ADDRESS: 257 S 16TH ST

Proposal: Install aluminum windows

Review Requested: Final Approval

STAFF RECOMMENDATION: Denial, pursuant to Standard 6.

**EXISTING WINDOW
DETAILS**

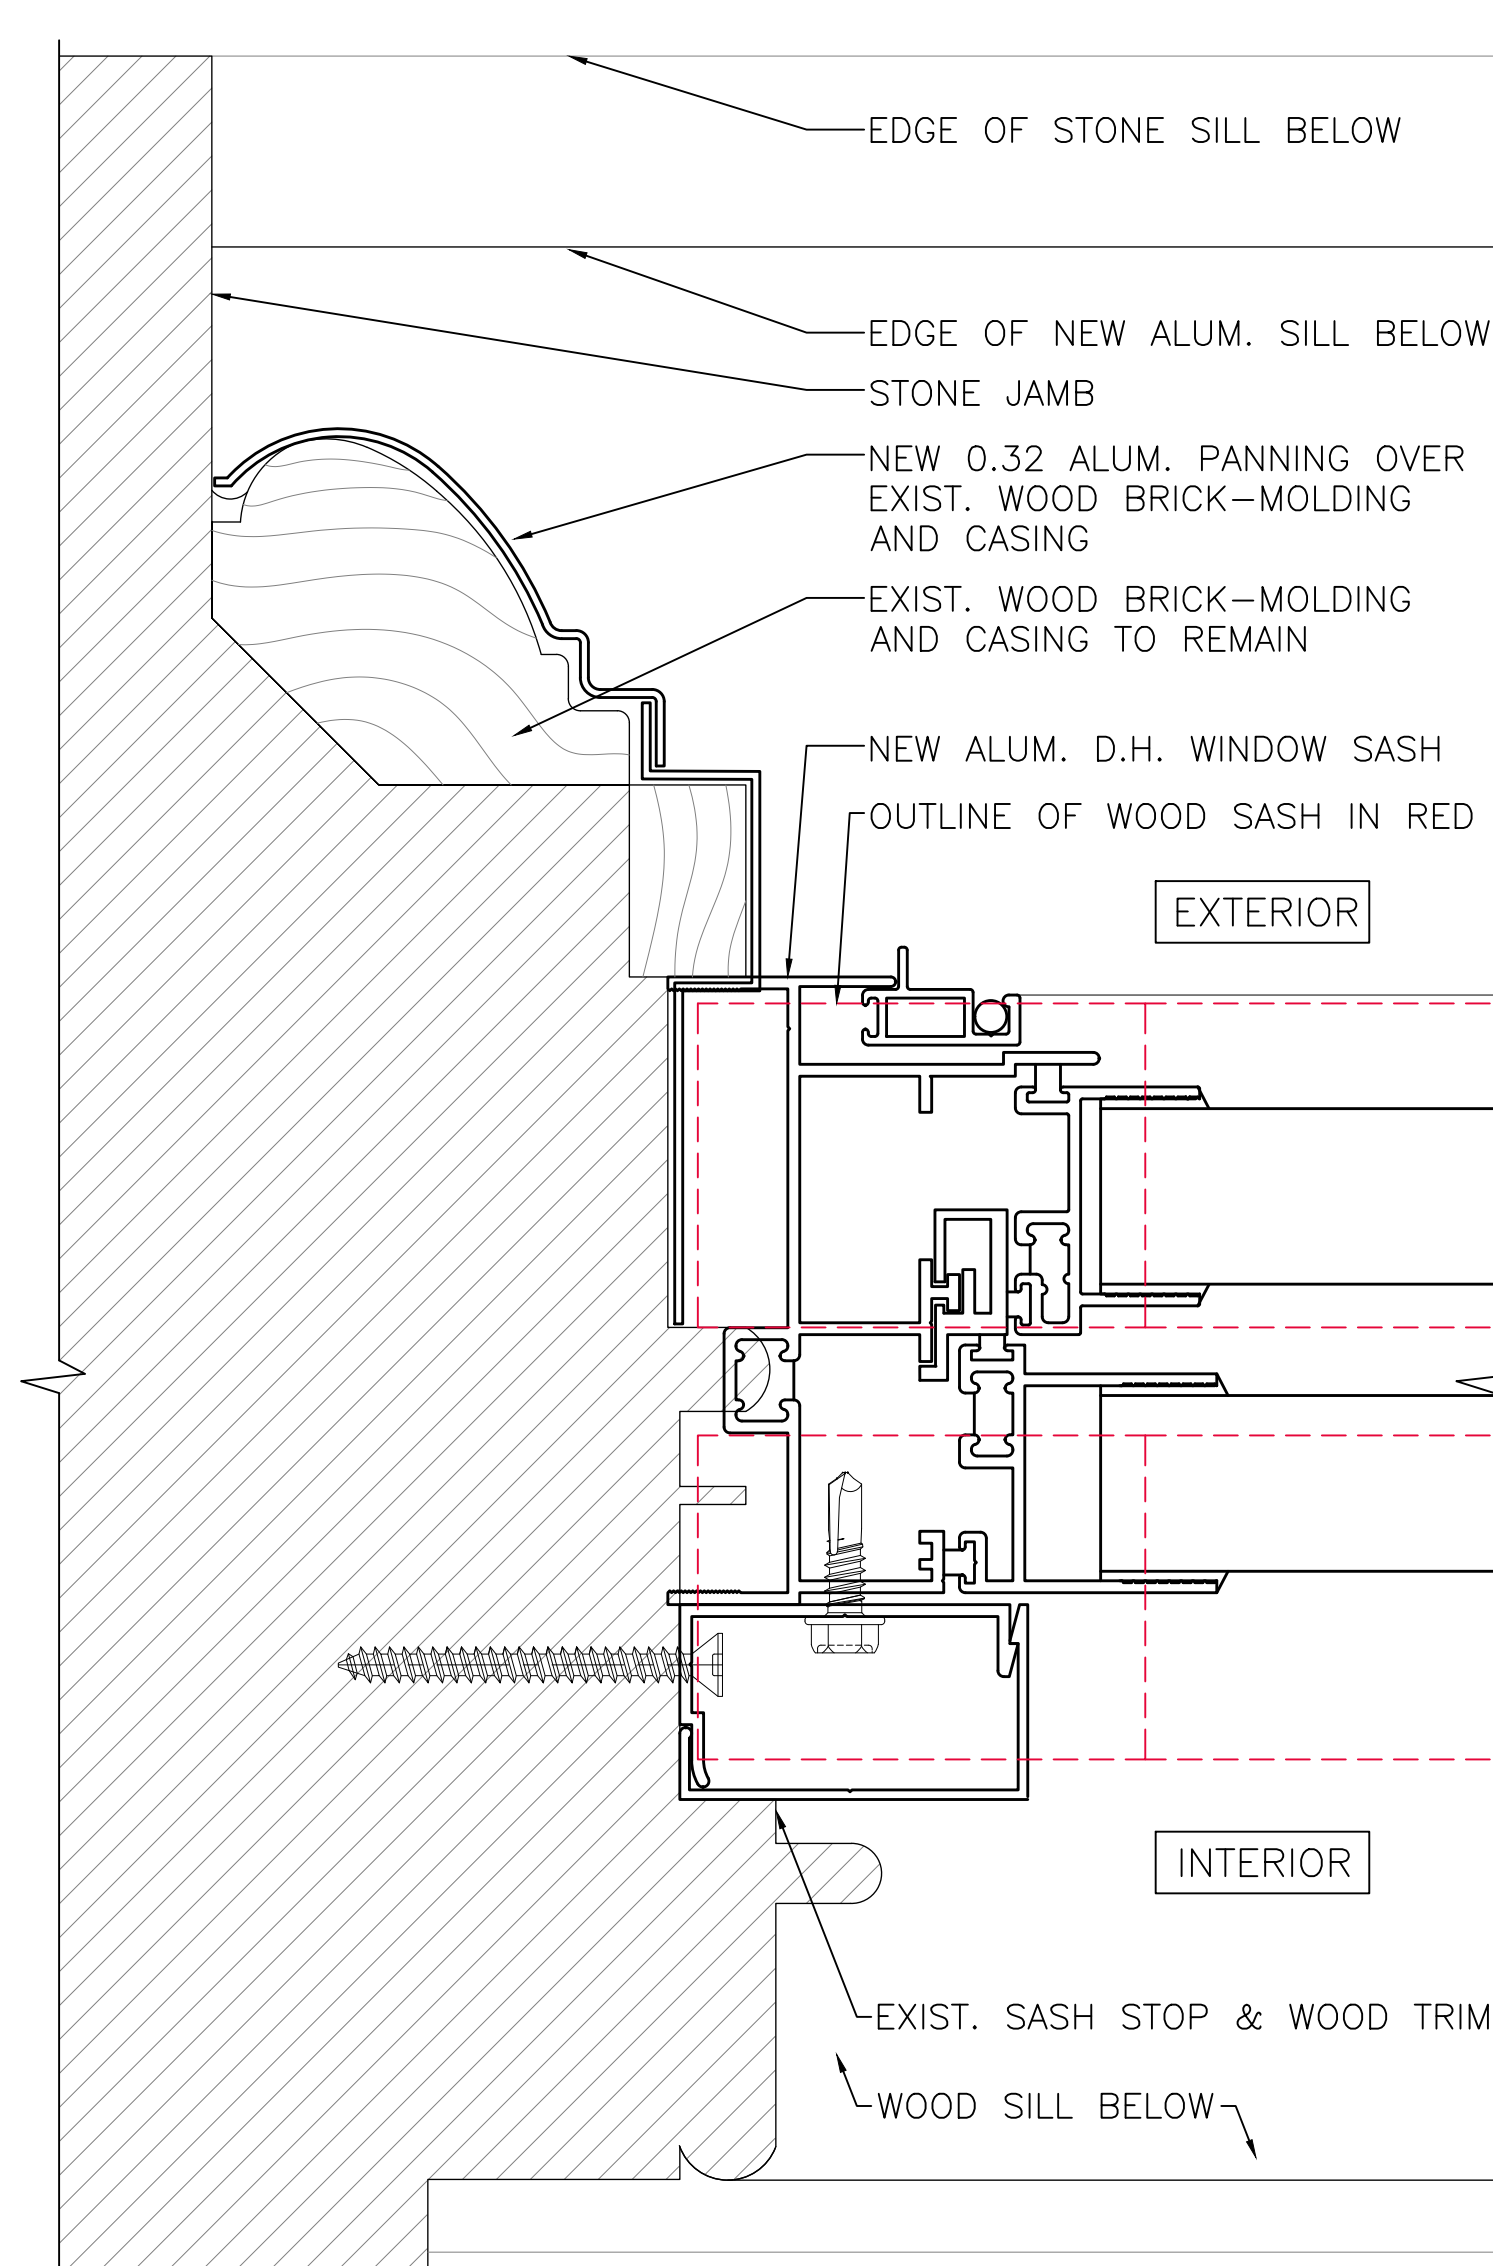
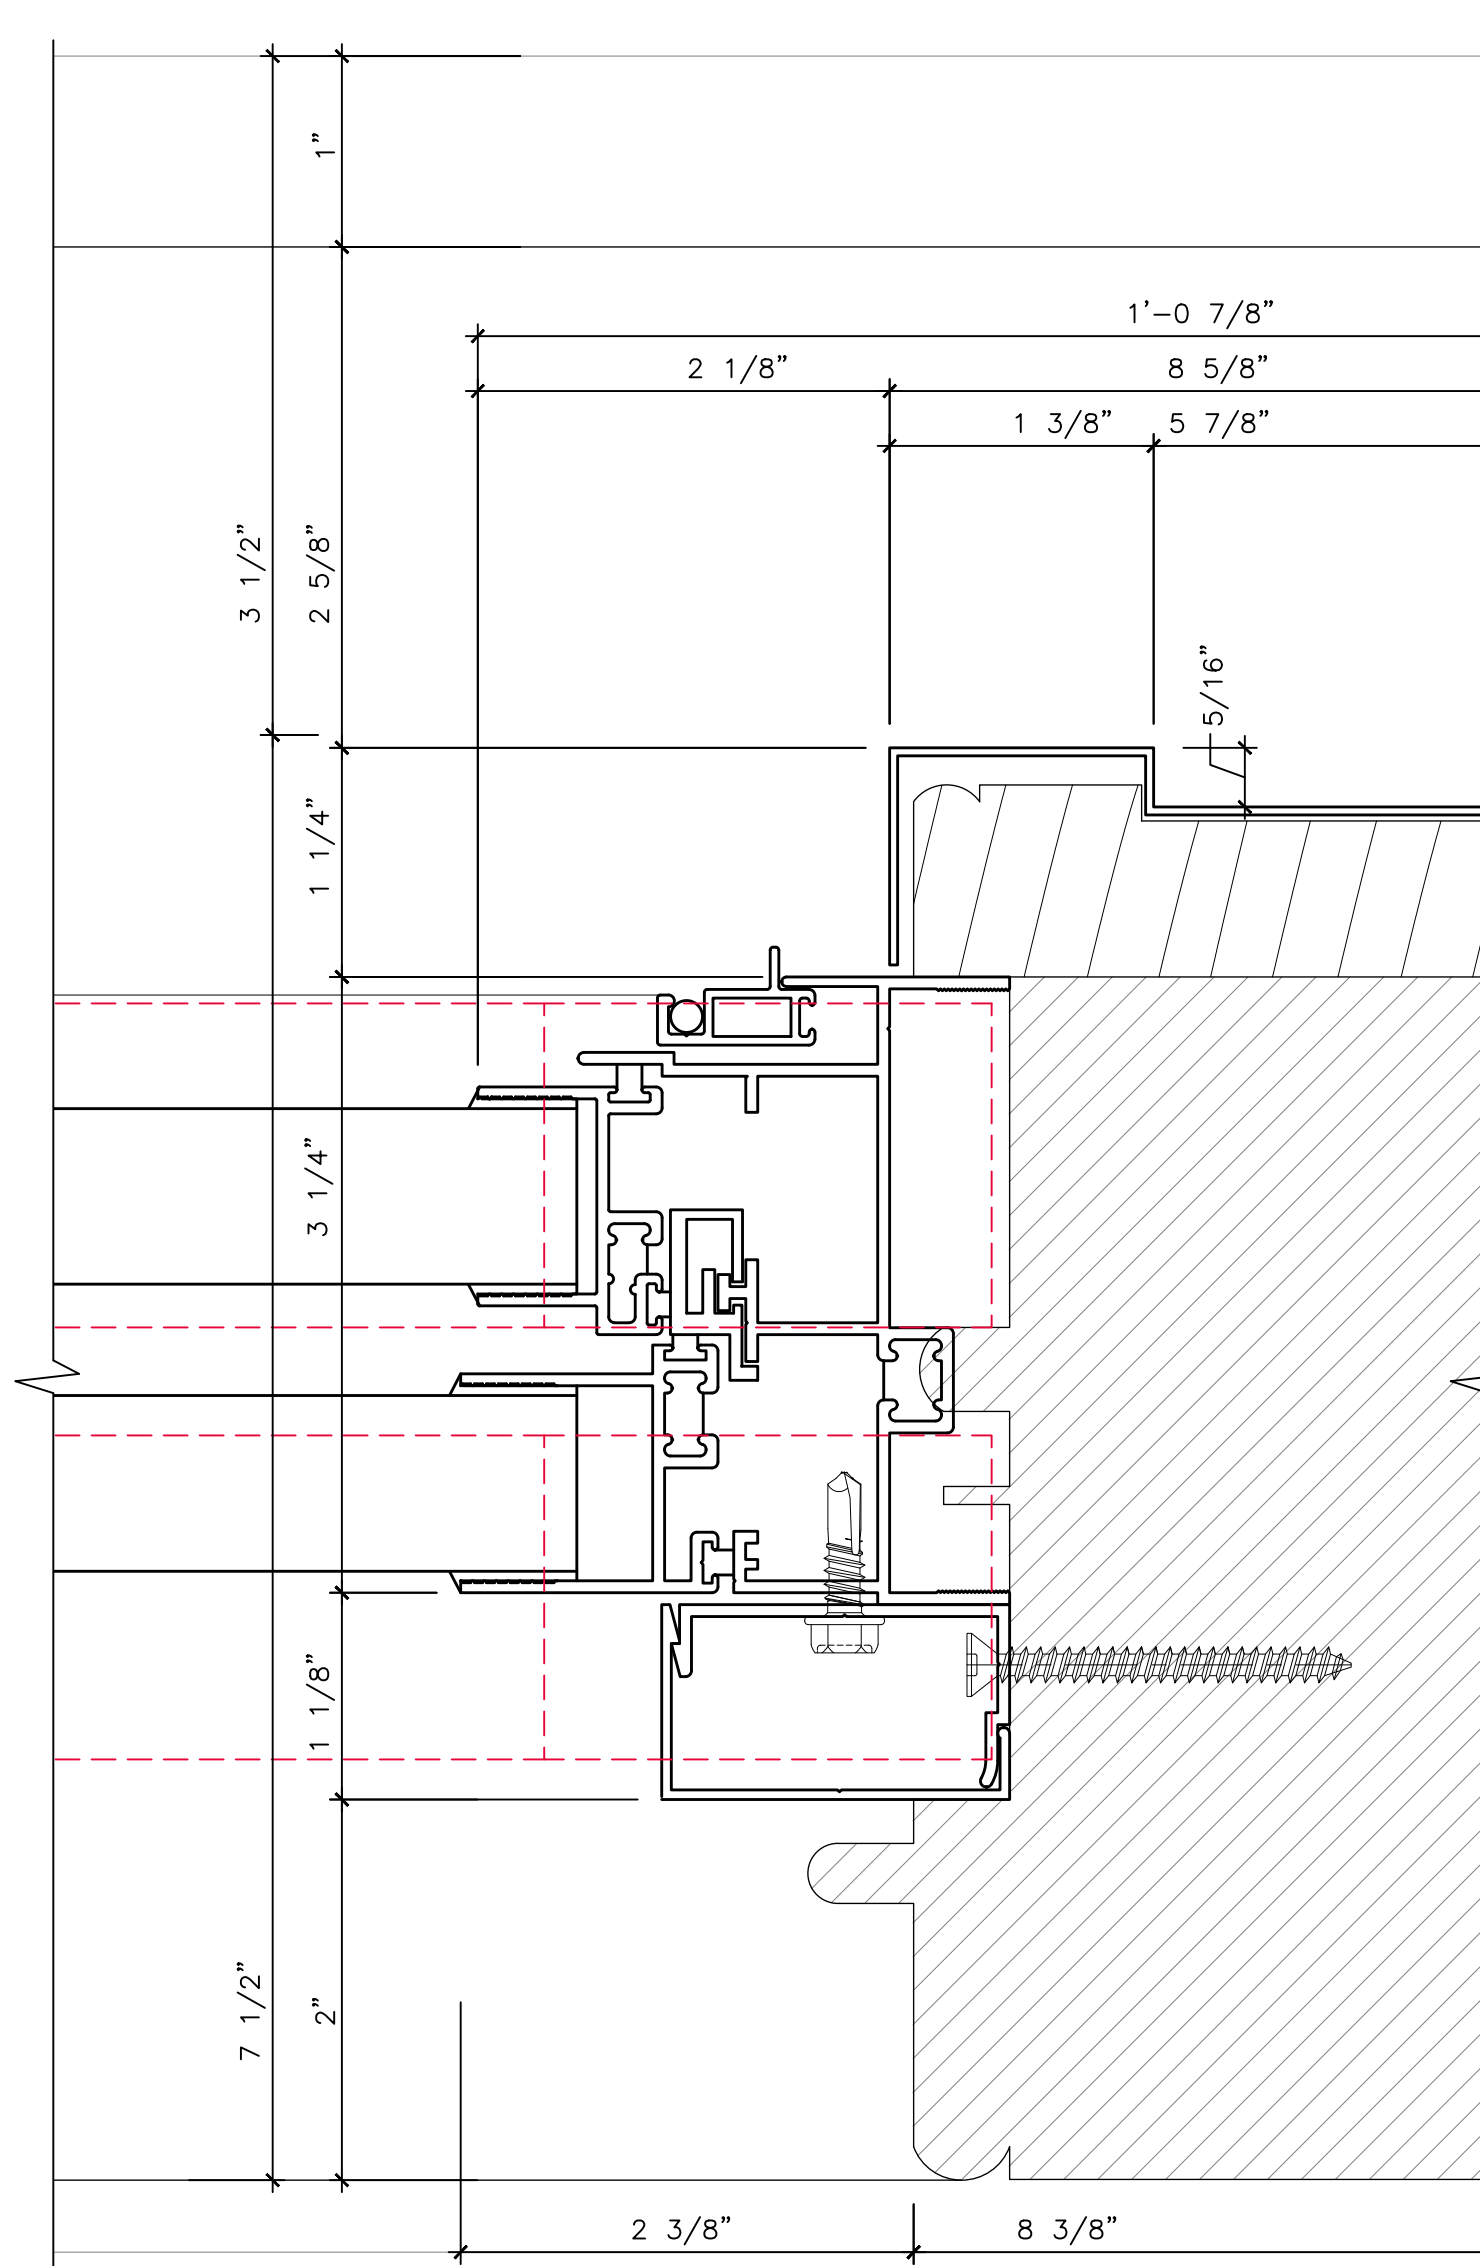
- *Standard 6: Deteriorated historic features shall be repaired rather than replaced. Where the severity of deterioration requires replacement of a distinctive feature, the new feature shall match the old in design, color, texture, and other visual qualities and, where possible, materials. Replacement of missing features shall be substantiated by documentary or pictorial evidence.*
 - o The proposed aluminum system has a significantly flatter profile between the sash and the glazing, changing the spatial relationships and visual qualities as well as texture of the original windows. The proposed aluminum windows do not replicate the appearance of the historic wood windows, failing to satisfy Standard 6.
